City of Houston Pedestrian and Bicycle Road Safety Audit

**Houston Safer Streets Initiative  
Top 12 Intersections  
Pedestrian/Bicycle Road Safety Audit  
First Six Locations**

Conducted:  
**September 24 - 28, 2018**

Figure 5: A vehicle travels through the intersection after the start of the opposing green signal and walk indication start.

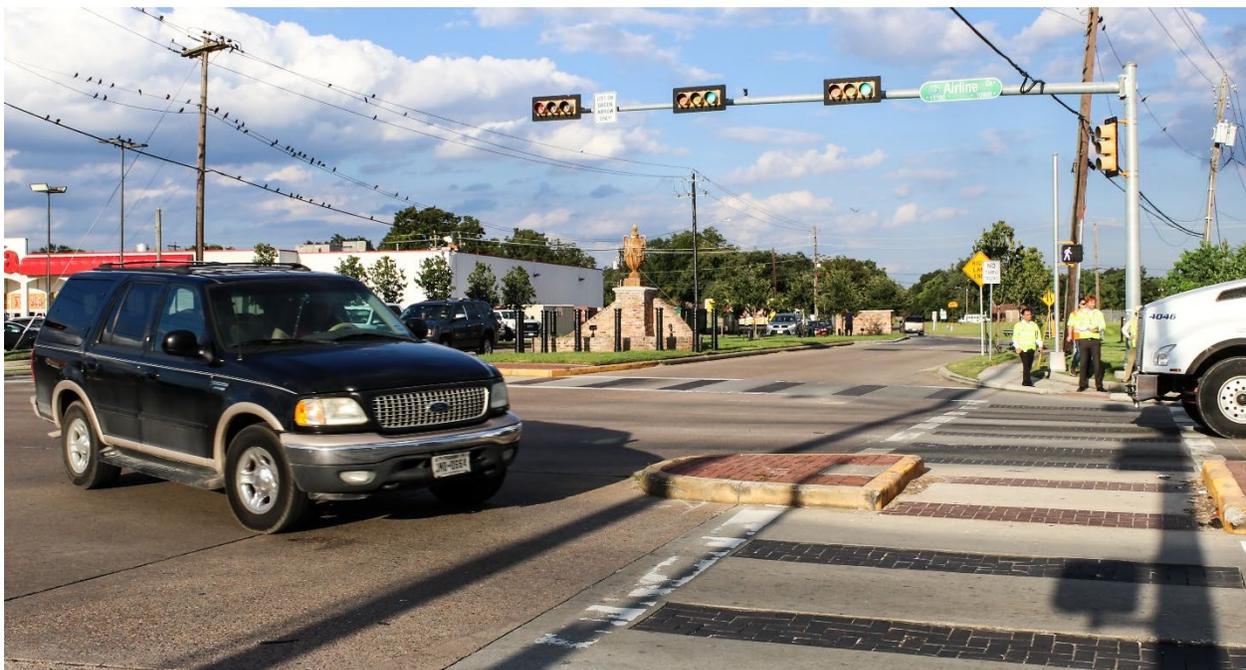
The six locations studied by this RSA team represent a diverse set of conditions throughout the City of Houston from downtown one-way streets to core neighborhoods to more suburban areas further away from the city's core. All six of the locations were identified as having some concern over the safety and ease of use for pedestrians and bicyclists, using a combination of crash data, feedback from BikeHouston and LINK Houston, and other sources. Most of the sites have frequent bus routes with strong bus ridership, along with the associated need to cross the street for access to transfers, businesses, schools, or residences nearby. Most of the locations had nearby commercial developments that generated additional pedestrian and bicycle use, particularly between the commercial activity and the bus stops. All of the locations had noted concerns with motor vehicle travel speeds. Two of the locations were considered critical points of crossing as part of regional bicycle networks or planned networks. Three locations had nearby high schools that affected the operations and the type of roadway users during the before and after school periods of each day. Three of the locations with signals included protected signal phasing for left turns and overlap phases for some right turns. Motor vehicle drivers were frequently aggressive in making turning movements including entering the intersection on yellow (and red) and making right turns without yielding to pedestrians (see Figure 5). Pedestrians observed during the study

- Recommendation: Pilot and evaluate adding pedestrian recall phases:
  - Across Airline during peak pedestrian periods such as school arrival/dismissal, PM peak.
  - Across West for all time periods.
- Recommendation: Request HPD enforcement, particularly towards aggressive turning traffic pushing yellow and red indications and failing to yield to pedestrians (see Figure 5).

Figure 10: Visibility of overhead signs

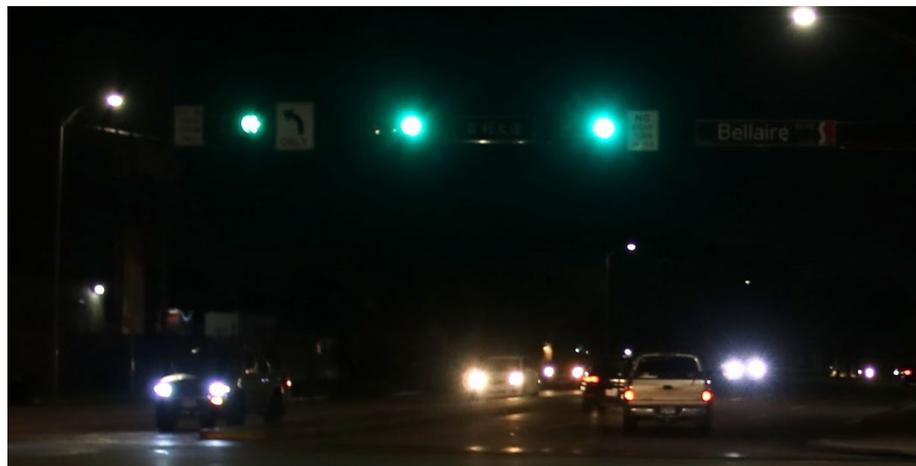
Supplemental one-way signs were mounted high on the signal mast arms outside of the headlight view for most vehicles. The team also noted issues with the visibility and legibility of street name signs and the visibility of no turn on red signs.

- Recommendation: Evaluate the placement of one-way signs in the downtown core for headlight visibility and implement changes as other work is performed.
- Recommendation: Evaluate street name sign size and placement for large intersections, and consider the use of internally illuminated signs.
- Recommendation: Install retroreflective border backplates at signalized intersections with safety concerns as a low-cost first step.

**Figure 11: Crosswalk pavers and markings conditions.**

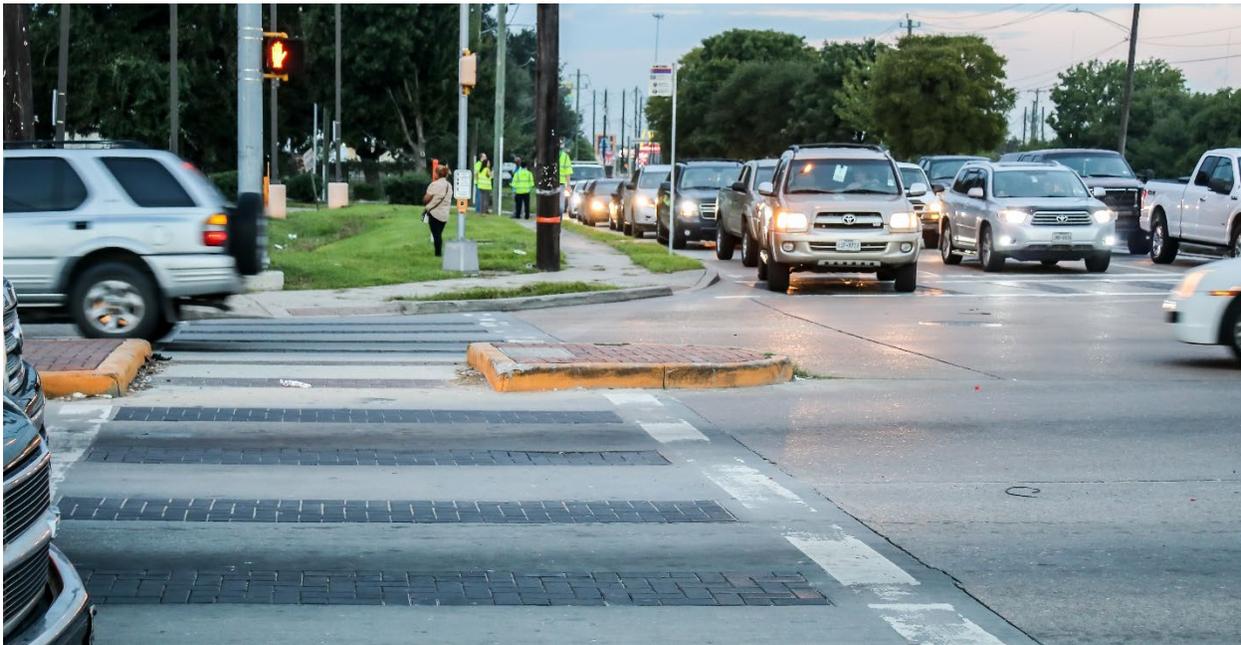
The crosswalks were marked with transverse lines only, and the markings are faded underneath the wheel paths of the through traffic. Pavers were used between the transverse lines but had started to settle in some places and were located primarily in the wheel paths (see Figure 11). The medians included bull noses on the near side of the crosswalk, adding some additional protection for those waiting in the median to cross. Two corners had single ADA curb ramps that are not the preferred design, and both were narrow relative to travel in the direction of the crosswalk because of the angle they were installed. The pushbuttons had been upgraded to APS, but most could use location adjustments to have level landing pads adjacent and better aligned with the crosswalks.

- Recommendation: Add high visibility white crosswalk markings between pavers in the crosswalks and consider wider transverse stripes (see Figure 11).
- Recommendation: Evaluate and update signal timing for all time periods (see Figure 8).
  - Eastbound left turn is short during school dismissal period.
  - Additional southbound green time to flush out AM Peak traffic
  - Northbound left turn is short during all observed periods.

Figure 13: Morning drop off queues.

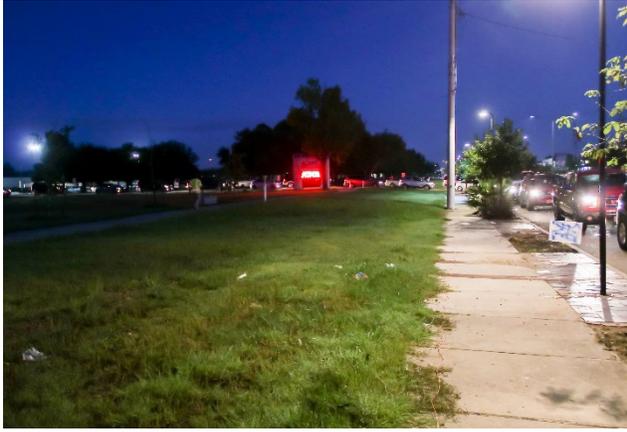
The school has significant impact on the operation of the intersection. During the morning drop off period, vehicles leaving the drop off area are limited by the signal timing of southbound traffic on Airline, resulting in long queues north on Airline and onto the school property (see Figure 12). The commercial parking lots along the east side of the roadway are frequently used as pick up and drop off points for students, which results in students crossing midblock to and from the school. During the morning arrival period, this occurred during darkness with unpredictable movements at the driveways due to the queue backup from the signal, and students moving between stopped cars at varying points along the road (see Figure 13). During the afternoon pickup period, there are fewer queues in the school driveway. Students leaving the school going east used a single sidewalk to gain access to the sidewalk along Airline, and many students crossed the street there despite the lack of a marked crosswalk and walking between vegetation in the median.

Figure 28: Potential lane reconfiguration and pedestrian refuge.

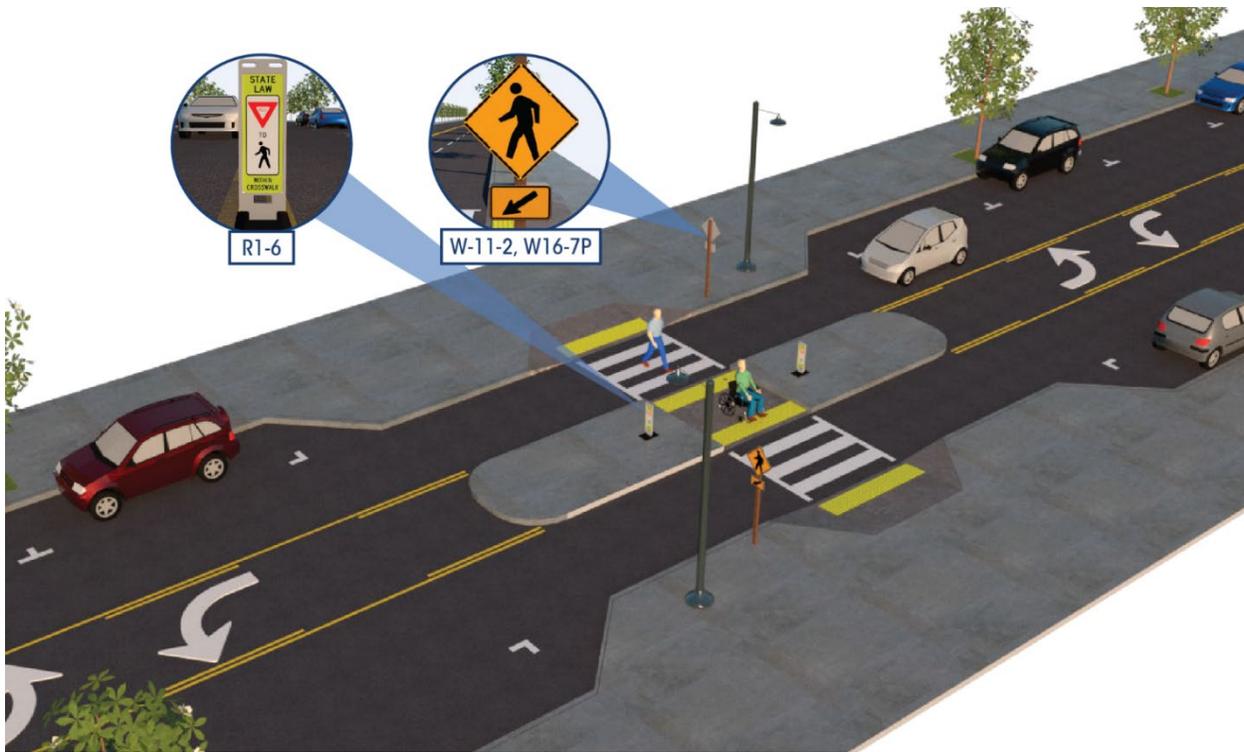
- Recommendation: Address the ease of crossing 11<sup>th</sup> for bicycles and pedestrians through physical controls.
  - Preferred option: Lane reconfiguration along 11<sup>th</sup>. A 4-to-3 lane conversion with bike lanes along 11<sup>th</sup> St, which would slow vehicle speeds for the entire segment and allow for a median refuge to break the crossing into two stages (see Figure 28).
    - The location should be evaluated for need of a Rapid Rectangular Flashing Beacon or PHB if there is a continued need for additional protection after the installation of a raised median and lane reconfiguration.

- Secondary option: Add a PHB or toucan crossing. These options would provide a protected crossing for bicyclists and pedestrians, but not control speeds along the segment of 11<sup>th</sup>.

Figure 31: Missing pushbutton and misaligned truncated domes.

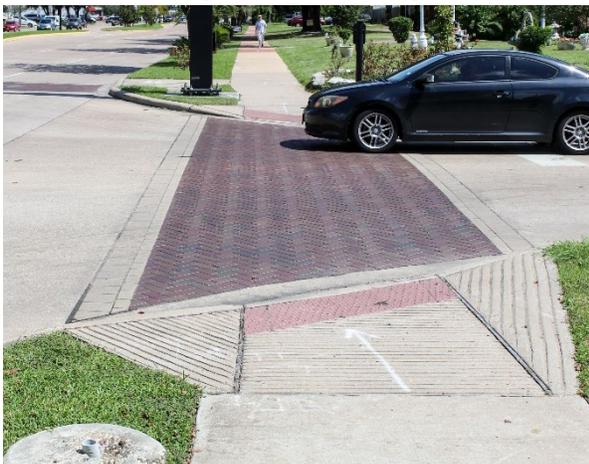
At the intersection of Bellaire and Pella one pushbutton was missing (see Figure 31), and several were at inaccessible locations (see Figure 32). Truncated domes at this intersection did not align with the intended crossing direction (see Figure 31). A school crossing warning sign and plaque needed to be

- Recommendation: At Bellaire and Pella intersection:
  - Relocate accessible pushbuttons next to level landing pads and within reach of paved area (see Figure 32).
  - Replace truncated domes that are misaligned.
- Recommendation: Evaluate usage of the 4<sup>th</sup> westbound through lane for possible conversion to a bus and right turn only lane (see Figure 33).
- Recommendation: Consider installing microwave or other sensor to detect pedestrians in crosswalk across Bellaire to extend time only when needed.
- Recommendation: Add truncated domes in median if pedestrians are expected to cross in two stages (see Figure 34).
